This technical bulletin outlines the procedure for fitting part number 0810-RFTT-Kit (Retro fit tail tip kit) to existing machines

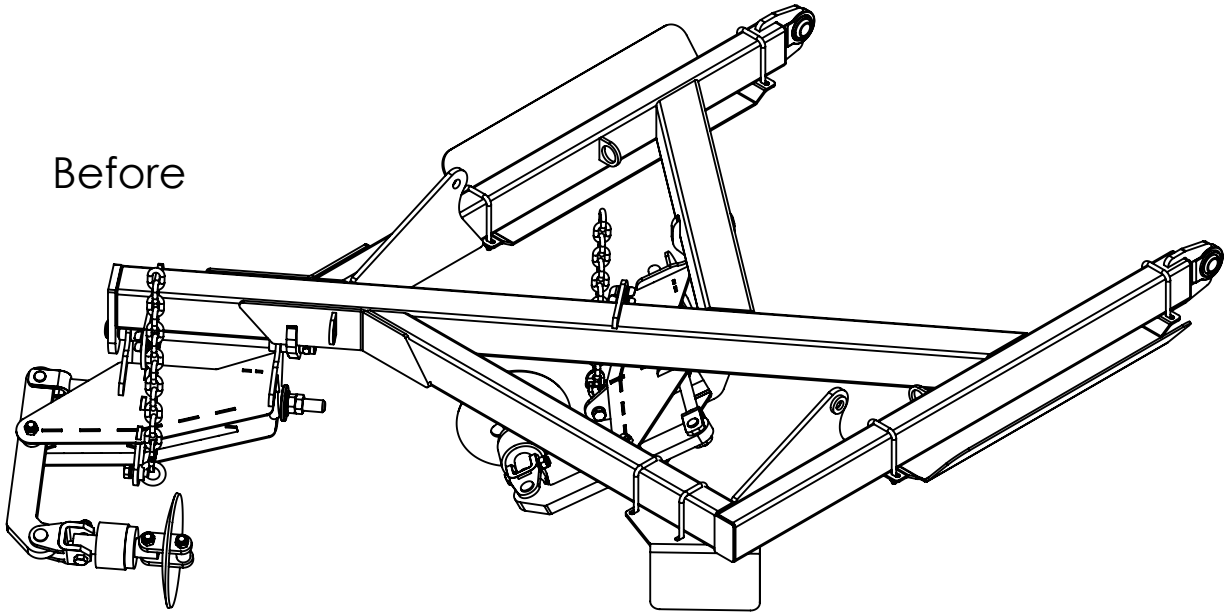
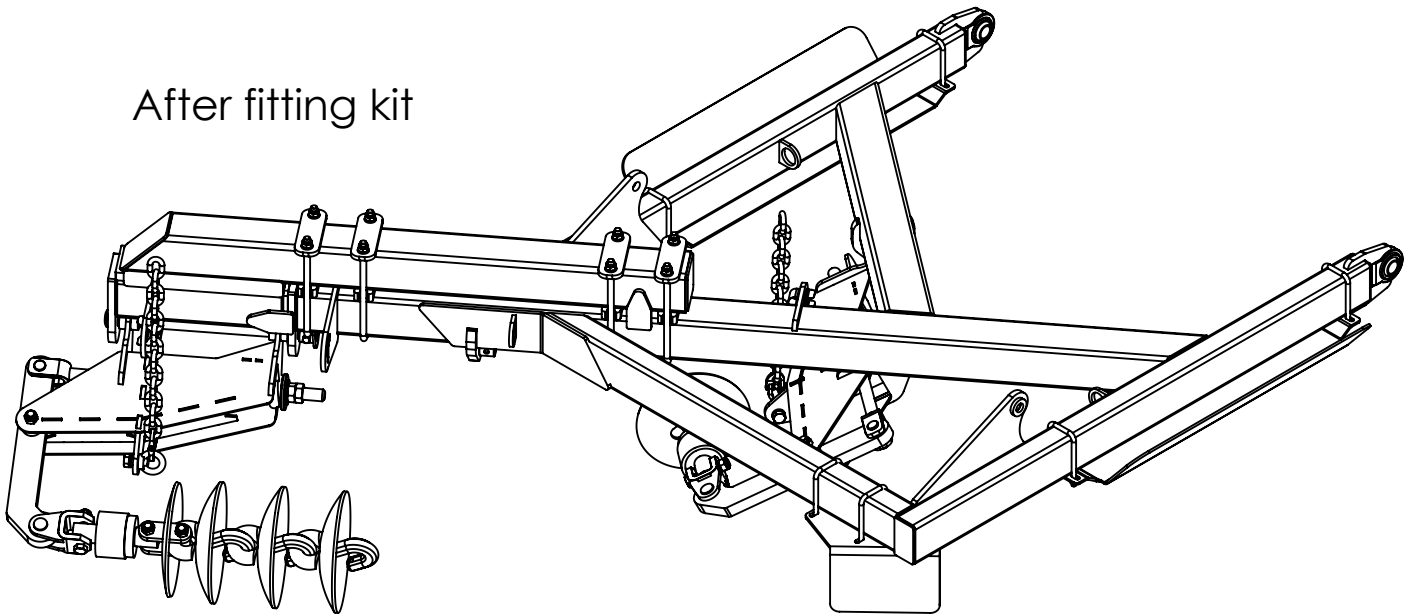
The machine is now ready to be used. This kit adds 3 chain links to the RHR chain allowing more overlap at the rear of the machine.

Step 2:

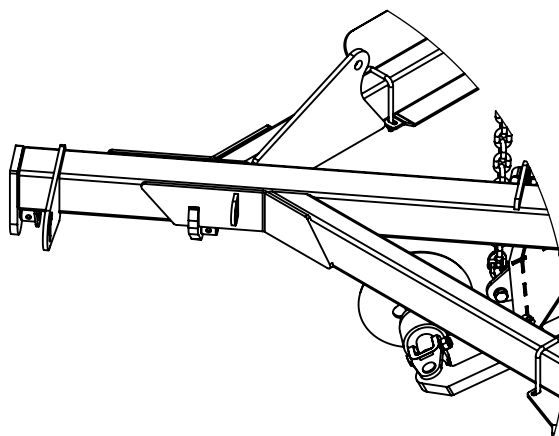
Remove rear tension box by removing the pivot pin and adjuster chain

Step 3:

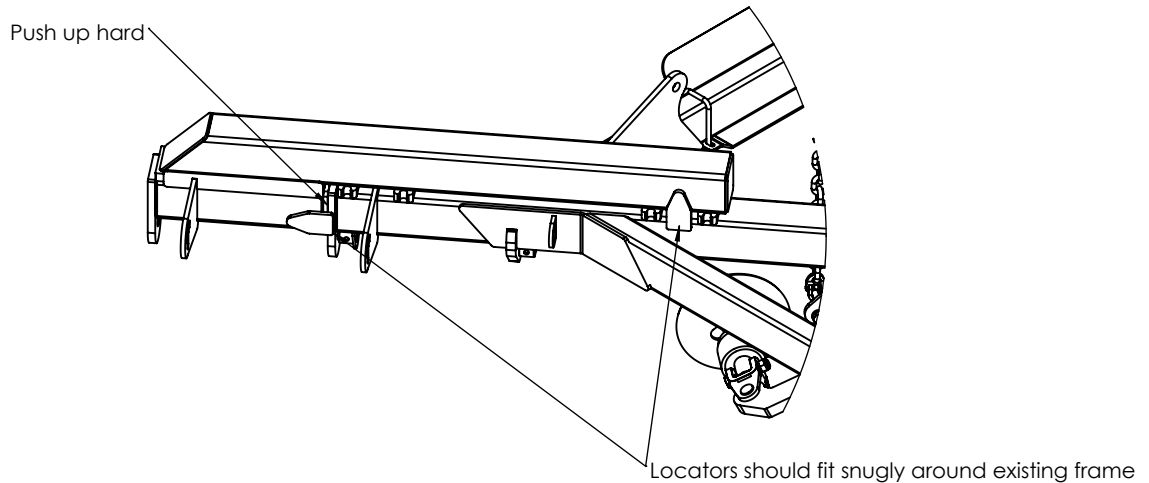
Place new part 0810-RFTT-FAB into position ensuring all mating surfaces are touching as shown below

Step 4:

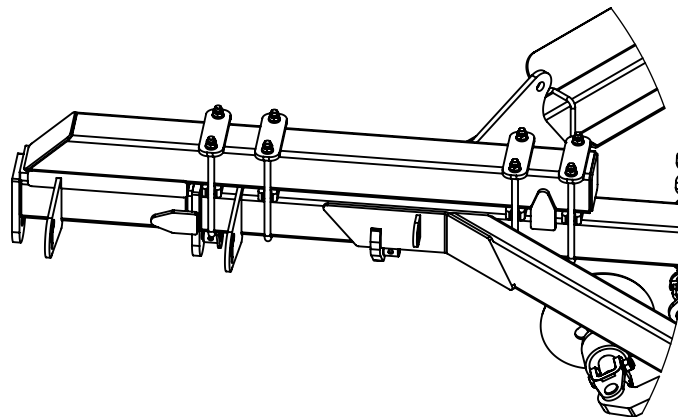
Using the U-Bolts and plates supplied clamp the fram into position as shown below

Step 5:

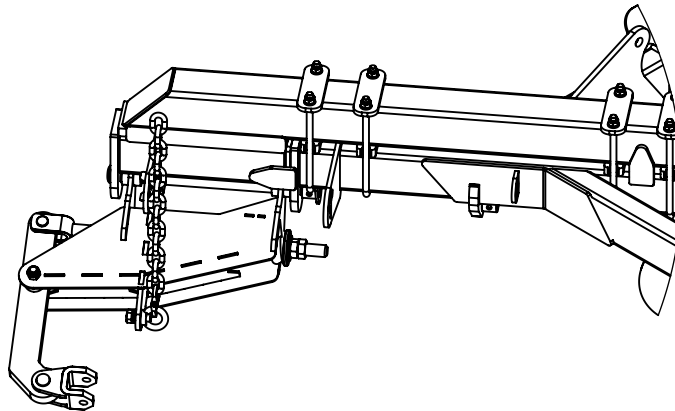
Re fit the chain tension assembly using the existing pivot pin into the new location as shown below

Step 6:

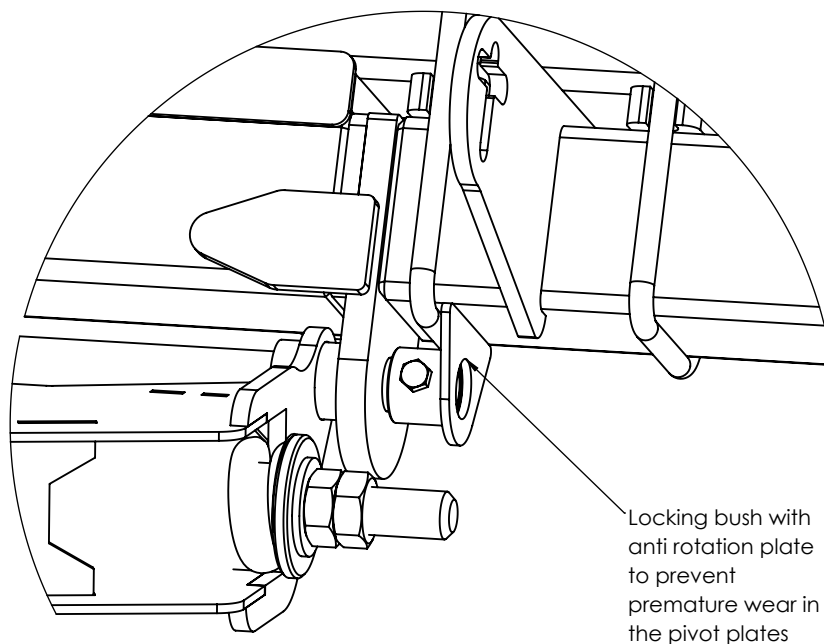
Lock the pivot pin into position using the Locking bush (0810-RFTT-LC) supplied as shown below

Step 7:

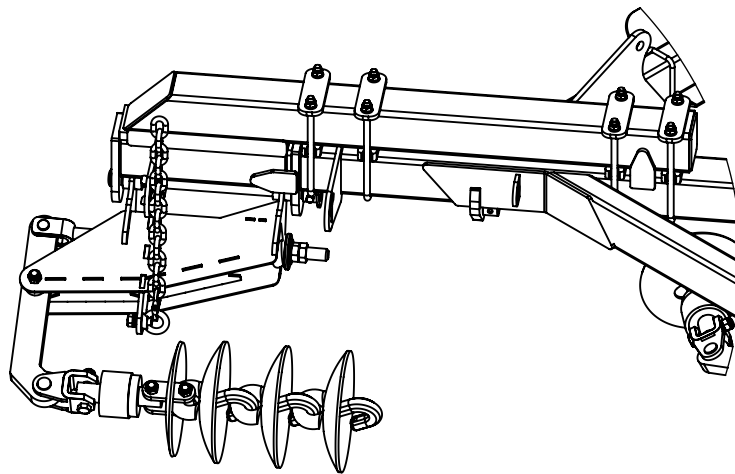
Add the 3 extra chain link discs to the existing chain and reconnect to the swivel
